Item ID: D206-642-341BL

Item Name: Replacement Skidtube (Fits LH or RH)

DRAWING NO. D2650	TITLE 206/407 SKIDTUBE ASSEMBLIES	REV. F	DART AEROSPACE LTD ENGINEERING ORDER		D.E.O. NO. D2650-F-1	SHEET NO. SHEET 1 OF 1	SCALE NTS
DRAWN <i>JP</i>	CHECKED <i>A.P.</i>	MFG. APPR. <i>AA</i>	APPROVED <i>TH</i>		DE APPR. <i>TH</i>		
DATE 12.10.12	DATE 12.10.22	DATE 12.10.22	DATE 12.10.22		DATE 12.10.22

CHANGE C'BORED WELDED CROSSBOLT SPACERS TO SWAGED SPACERS

AMENDMENT TO DETAIL B
NOT TO SCALE

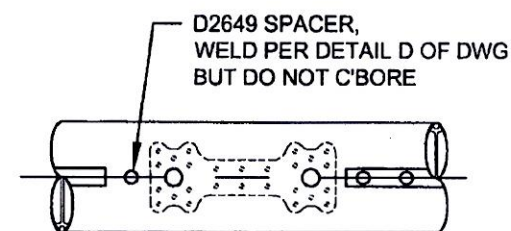
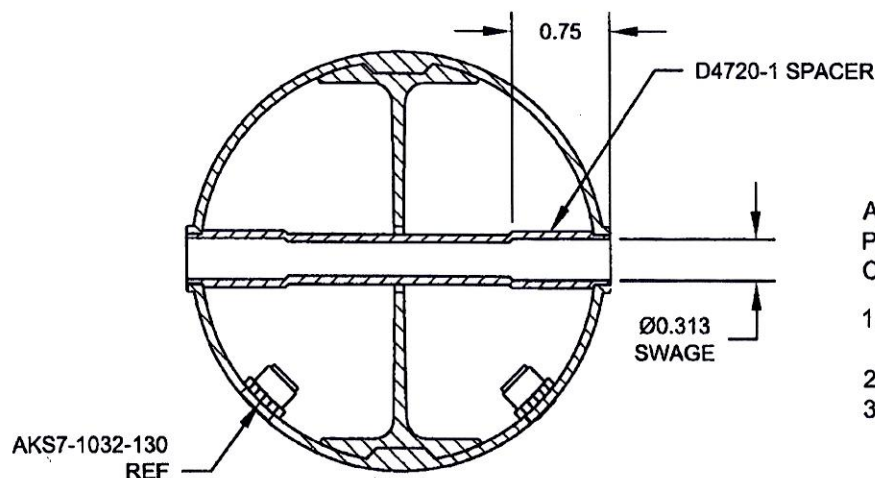
PARTS LIST IS AMENDED AS FOLLOWS:

IS:

QTY -1	QTY -3	QTY -5	QTY -7	PART NUMBER	DESCRIPTION
1	1	0	0	D2649	CROSS BOLT SPACER
16	17	19	23	D4720-1	SPACER

WAS:

17	18	19	23	D2649	CROSS BOLT SPACER
----	----	----	----	-------	-------------------

ADD DETAIL G BELOW, WHICH IS THE SAME SECTION VIEW AS DETAIL D OF DWG.

C'BORED HOLES ARE NOW SWAGED PER DETAIL G BELOW. FOR THE Ø0.375 HOLE THAT IS NOT C'BORED, WELD PER DETAIL D OF DWG (SEE AMENDED DETAIL B FOR REFERENCE).

AFTER DRILLING AND BENDING ASSEMBLY
PERFORM THE FOLLOWING FOR Ø0.375 HOLES THAT ARE
CURRENTLY C'BORED:

1. INSERT D4720-1 SPACER, 16 PL (-1) OR 17 PL (-3)
OR 19 PL (-5) OR 23 PL (-7)
2. SWAGE TO Ø0.313 X 0.75 DP PER QSI 002
3. TRIM / GRIND FLUSH PER QSI 002
